## **REMARKS**

The Office Action also requests a new title. By this Amendment, the title has been amended to --PLASMA DISPLAY PANEL INCLUDING METAL ELECTRODES FORMED ON TRANSPARENT ELECTRODES--.

[Fig. 1] RELATED ART

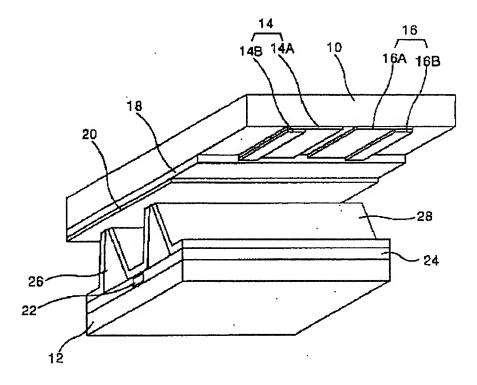
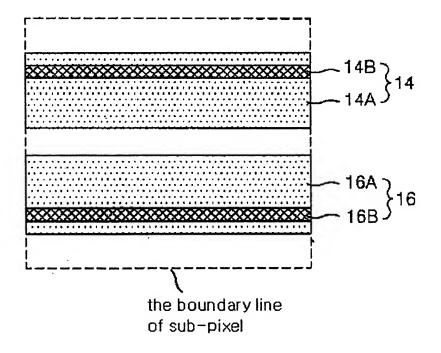
The Office Action objects to the drawings and requests that Figures 1 and 2 be labeled as --Prior Art--. In order to further prosecution, Figures 1-2 are labeled "RELATED" ART".

The attached 4 sheets of drawings include proposed changes to Figs. 1-2, 9-11 and 14. The changes have been marked in red. More specifically, Figs. 1-2 have been labeled as "Related Art," item 415 has been deleted from Fig. 9, and corrections have been made to each of Figs. 10, 11 and 14. The attached 4 sheets of "Replacement Sheets' replace the originally-filed sheets.

[Fig. 9]

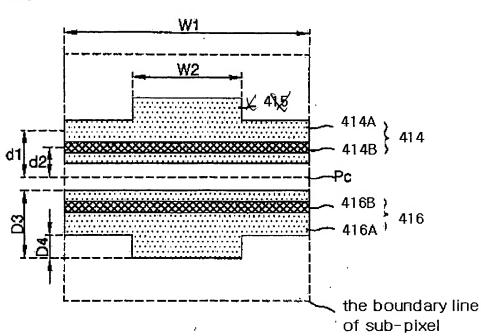
The Office Action also objects to the drawings under 37 C.F.R. §1.84(p)(5). More specifically, the Office Action states that item 415 in Fig. 9 is not mentioned in the description. By this Amendment, Fig. 9 is amended to delete item 415. The Office Action also states that items 314 and 316 in Figs. 8a and 8b are not mentioned in the description. By this Amendment, paragraph [0060] of the present specification has been amended to reference items 314 and 316 of Figs. 8a and 8b. No new matter has been added. See, for example, paragraphs [0044], [0045] and [0055] discussing features of Fig. 4. Withdrawal of the objection to the drawings is respectfully requested.
